Planning Commission Meeting
Thursday, November 13, 2014
Meeting held at the Saratoga Springs City Offices
1307 North Commerce Drive, Suite 200, Saratoga Springs

Planning Commission Staff Report

Preliminary Plat Heron Hills October 13, 2014 Public Hearing

**Riverbend Townhomes
Site Plan, Preliminary Plat, MDA Amendment
Thursday, November 13, 2014
Public Hearing**

DRAWN MEC	CHECKED	PROJECT # 13118
DATE 7/10/14		SCALE 1" = 40'
SHEET C201		ENGINEER'S STAMP

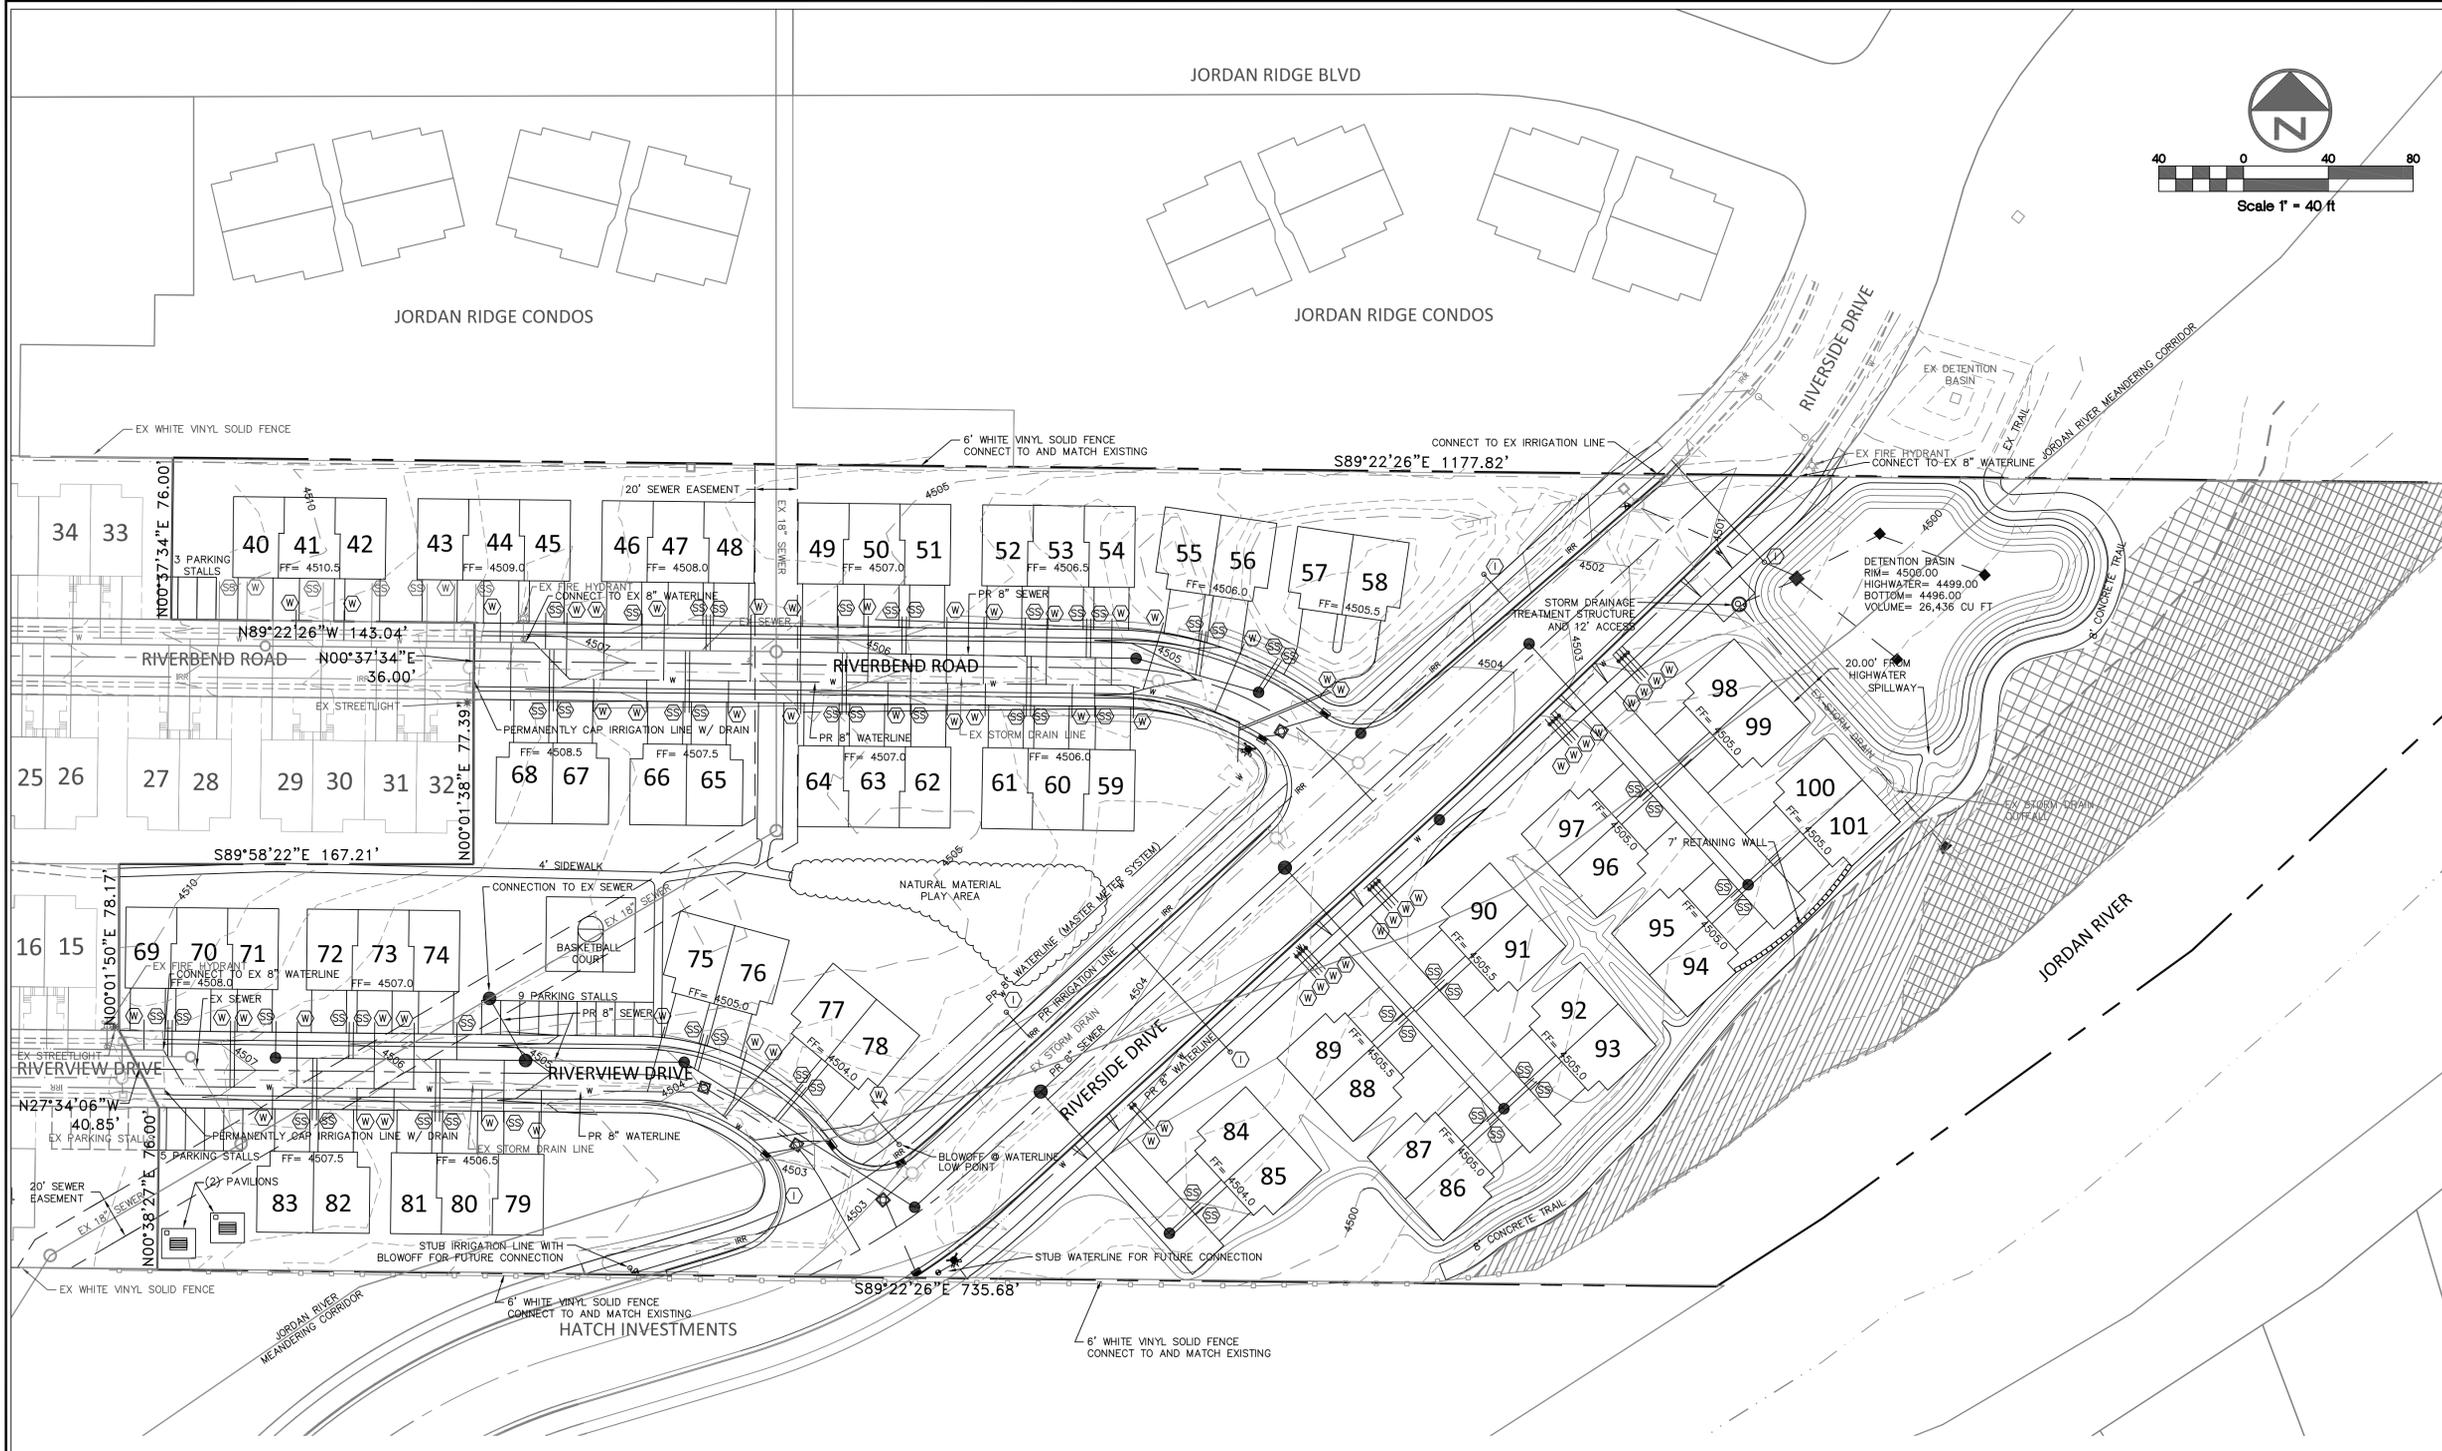
- 19.06, Landscaping and Fencing – **Complies with conditions**
 - Planting Standards & Design – appears to comply with number, location, design, and caliper.
 - Amount – 20% landscaping required (1.7 acres required; 4.5 acres provided)
 - Fencing & Screening – No fencing proposed. Fencing plans for the detention basin must be provided, due to the location of steep slopes to residences.
 - Clear Sight Triangle – Identified and maintained.
 - Fencing – chain link is prohibited; fencing must be modified to meet Code standards

1. The maximum number of units shall be 62.
2. Modifications required to bring the Site Plan and Preliminary Plat into Code compliance shall be made.
3. All other conditions of approval for the original MDA extension and amendment shall be met.
4. Any other conditions recommended by the Commission: _____
